Application No.: 10/614,004 page -2-

Art Unit 3749

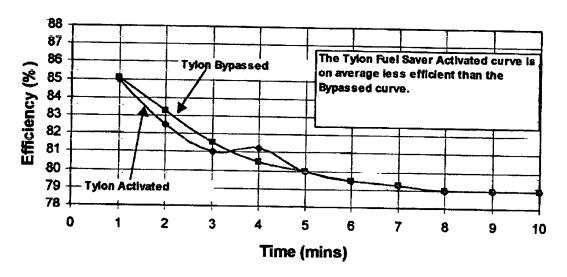
It can thus be said that the increase in energy input to the furnace due to fuel heating and an improvement in combustion efficiency was 3.558 Btu.

That is, an increased energy input of 0.09 % (This analysis did not include a possible improvement to the low level of propane slippage that can occur on burner ignition and extinction, as it was not measured. However, it would not be expected to add a significant amount to the increase in energy input).

The above increase in energy input is far outweighed by the measured decrease in fuel volume (2.3%) to the furnace due to the change in thermophysical properties of the fuel and temperature effects on the combustion system (orifice, burners, etc).

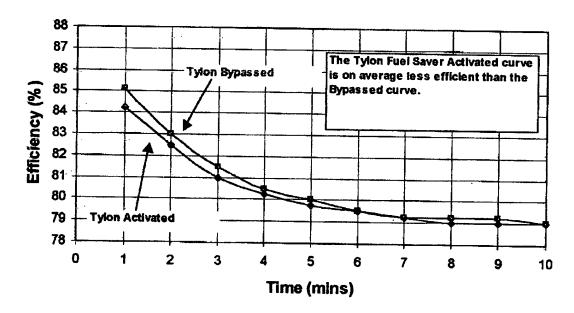
These overall efficiency figures were calculated using the "flue loss method". This method determines the sensible and latent energy lost in the combustion products going up the flue. The figures are determined by temperature differences between what goes in and what comes out and also from the flue Carbon Dioxide concentration, which gives an indication of the excess air level in the flue.

The Efficiency determined using this method includes both the energy output in the load air and the energy lost from the furnace to its surroundings.

There was a net decrease in the energy supplied to the furnace and an increase (or no change) in the energy being lost up the flue, so unless there was a significant change in the casing losses (which cannot be determined) there is no explanation for the dramatic increase in energy output in the load air being claimed.
